SUBDIVISION REVIEW SHEET

CASE NO: C8-2010-0051

SUBDIVISION NAME: THE SPRINGS OF WALNUT CREEK PRELIMINARY PLAN

**THE SPRINGS
OF WALNUT CREEK**
WASTEWATER EXHIBIT

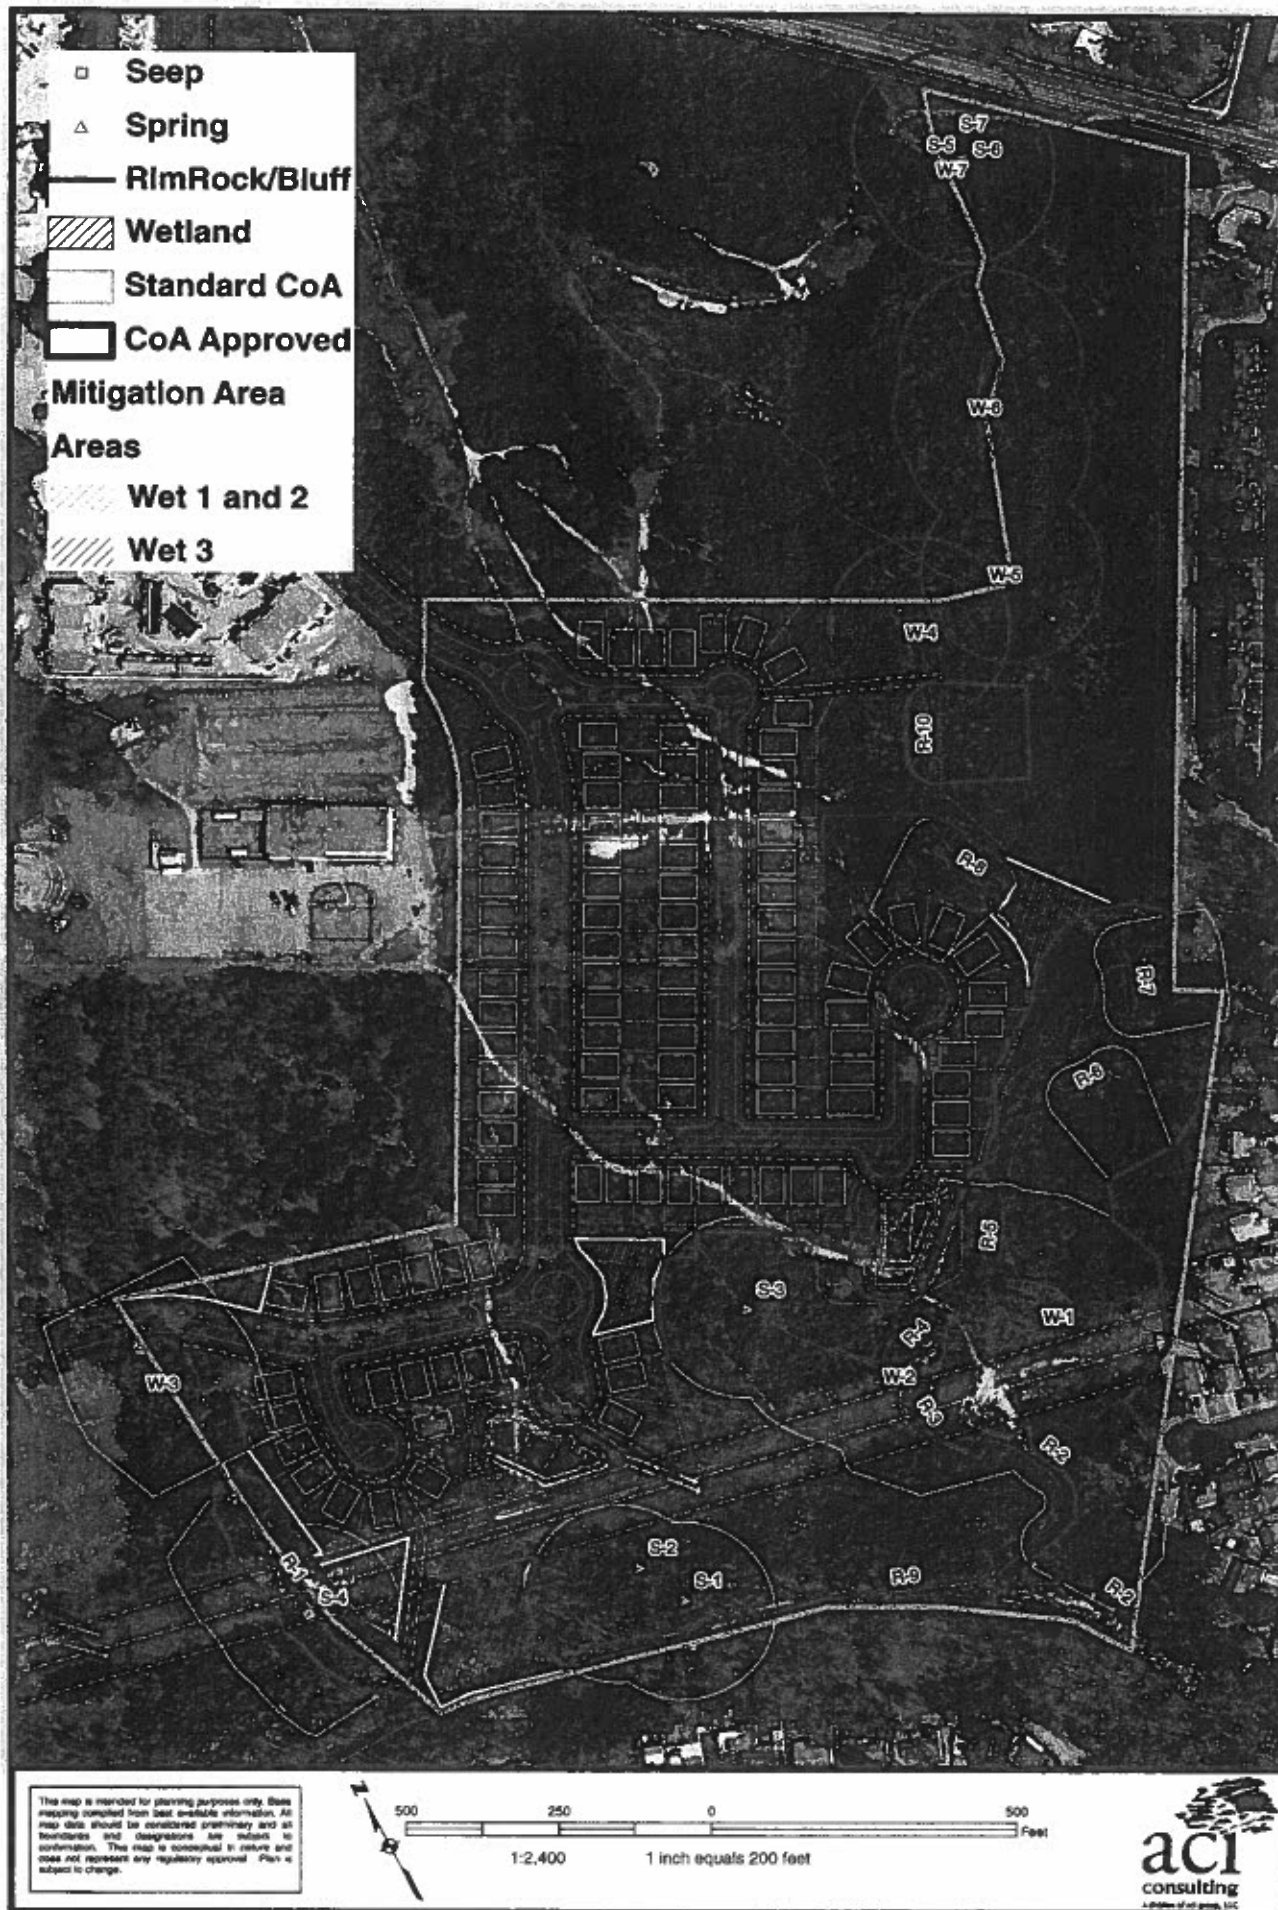
The applicant is proposing an eight inch wastewater line collection system to pass through the critical water quality zone and tie into the existing 54 inch mainline located in an existing drainage easement in the critical water quality zone. The easement and requested wastewater line is located approximately 60 feet away from the creek centerline to the centerline of the easement and is located outside of the creek basin. The proposed wastewater line runs near perpendicular to the creek until within the existing 40 foot easement and 54 inch mainline. Then, to avoid building a more environmentally intrusive new manhole, the applicant is proposing to run approximately 40 feet of the new line parallel to the critical water quality zone to tie into an existing manhole eye-out. Though tying into an existing wastewater line already located in the critical water quality zone, the proposed 40 feet section that runs parallel to the critical water quality will not be code compliant. Thus, the environmental variance for the proposed work has been requested.

In the context of the variance request, staff confirms that the line location is the least intrusive location for the line placement and represents minimum departure from code. Staff also agrees with the applicant that building a new manhole to tie into would be more environmental degrading than would running the line parallel in the critical water quality zone to tie into an existing manhole eye-out. Staff has also consulted with Austin Water Utility and has confirmed that no other line location is feasible. For the aforementioned reasons, staff recommends approval of the environmental variance request and has required that the disturbed area within the critical water quality zone be revegetated per 609s native seeding and direct planting.

Application Name: Springs of Walnut Creek
Application Case No: C8-2010-0051
Code Reference: Land Development Code Section 25-8-392 Development within the Critical Water Quality Zone
Variance Request: To allow approximately 50 feet of 8 inch wastewater line to be constructed parallel and within the CWQZ of Walnut Creek to tie into an existing 54 inch mainline.

Yes. The proposed location is less environmentally degrading than the code compliant option of running the line perpendicular through the critical water quality zone and building up a new manhole eye-out. Though a 40 foot section of the proposed wastewater line runs parallel to the creek, there is an existing manhole eye-out at the proposed terminal point of the 8 inch wastewater line. Thus, though code compliant, building up a new manhole would be more environmentally degrading than utilizing the existing manhole eye-out, albeit requiring the line to run 40 feet parallel to the creek.

Rationale: The line location is in the least intensive location. Tying into the existing manhole would be less environmentally degrading than building a new manhole.

RECOMMENDATION: Recommend approval
